# Rezoning Transportation Analysis

Petition Number: 2019-009

General Location Identifier: 03714104, 03714103

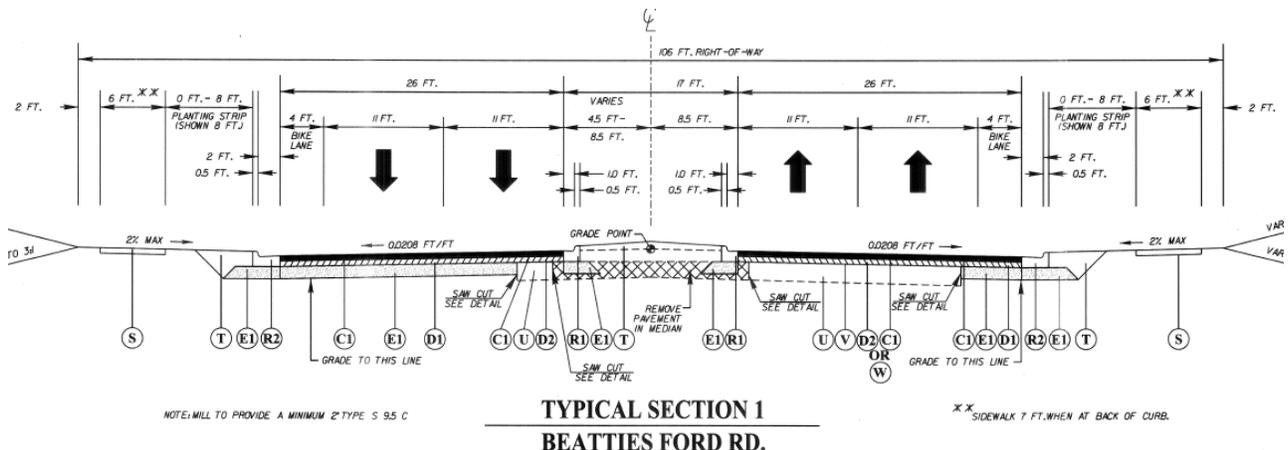
- d. The petitioner shall commit to implement two (2) 150' southbound left turn storage lanes with appropriate bay tapers at the site's northern entrance on Beatties Ford Rd. and at Trinity Rd. The below Beatties Ford Rd. typical section has been modified to eliminate the 4-foot on-street bike lane and add a 12' multi-use path along the site's Beatties Ford frontage. The petitioner needs to coordinate the site's Beatties Ford and Trinity Roads improvements with the City's Beatties Ford /Sunset Rd. Pedestrian Sidewalk Project (please contact Ms. Erin Pratt with CDOT at 704-336-1499).
